APPEAL SUMMARY

Appeal ID: 20767

Project Address: 6035 NE 78th Ct

Second FPP Checksheet

1 OVERALL FIRST FLOOR FIRE LIFE SAFETY PLAN
LS.1.00 SCALE: 1/8" = 1'-0"

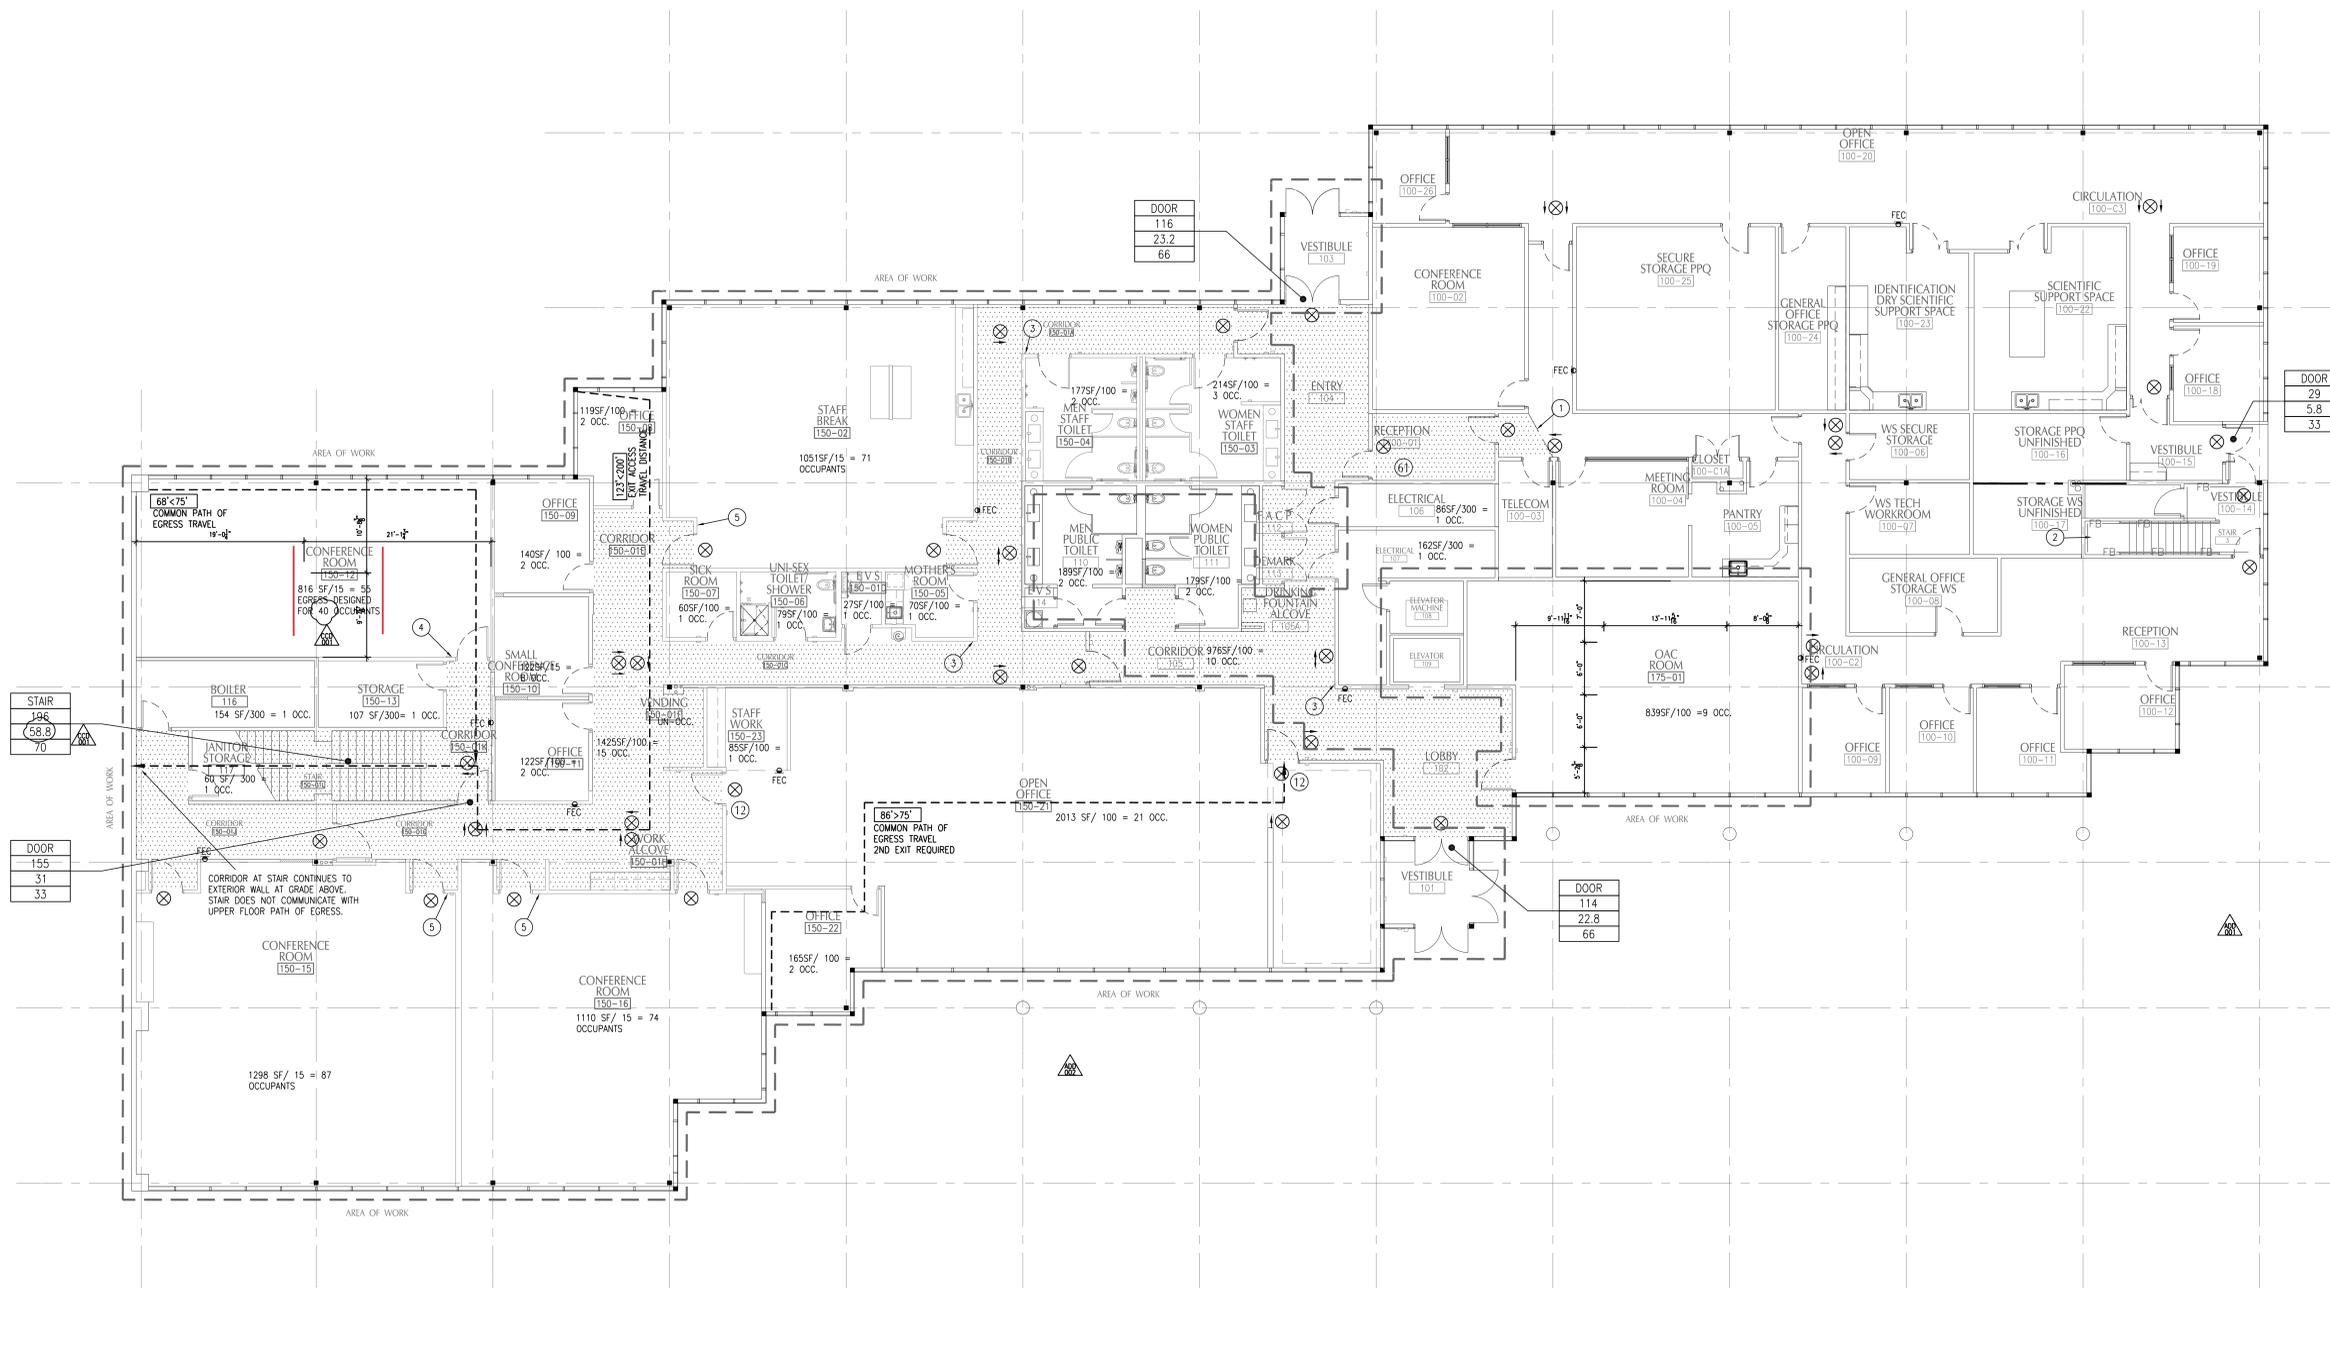
This appeal is to reduce the design occupant load to actual occupant load per the exception in OSSC 1004.1.2. The tenants have confirmed that seating and tables in this room will be designed for 24 people and the room will not ever be used by more than 40 people at a time. Signage will be posted to indicate a maximum occupancy of 40 in conference room 150-12. The conference room will not be occupied by more than 40 people at one time.

The code requires a second door when more than 49 occupants are in a space. Due to space and site constraints, a second door is not feasible to meet design occupant load requirements for an occupancy greater than 49. Because the conference room will not ever be occupied by more than 40 occupants at a time, one door is adequate for exiting.

Item #	Location on plans	Code Section	Clarification / Correction Required
1.	LS.1.00 A2.1.00 A2.1.01	107.2 1004.1 1008.1 1015.2	<p>Please provide design occupant load calculations and room square footages on the plans. For example: Conference Room 150-12 appears/scales to be 800 square feet. Showing the math = 800 sq.ft./15 occupant load factor = 54 occupants. This would require two egress doors. Additional checksheet items may occur once this information is on the plans.</p> <p>Re-check 8/5/19: The building code basis egress design on design occupant load found in 1004.1. The design occupant load for Conference Rm. 150-12 is calculated at 55. This means the exiting will need to conform to this load:</p> <ul style="list-style-type: none"> a) 2 exit doors, 1/2 diagonal distance of room apart (not sprinklered) b) Both exit doors swinging out in direction of egress travel <p>The only way to reduce the design occupant load to actual occupant load is through a building code appeal (which would need to be granted prior to plan approval): https://www.portlandoregon.gov/bds/34196</p>

Reduction in calculated occupant load for conference room: Denied. Proposal does not provide equivalent Life Safety protection.
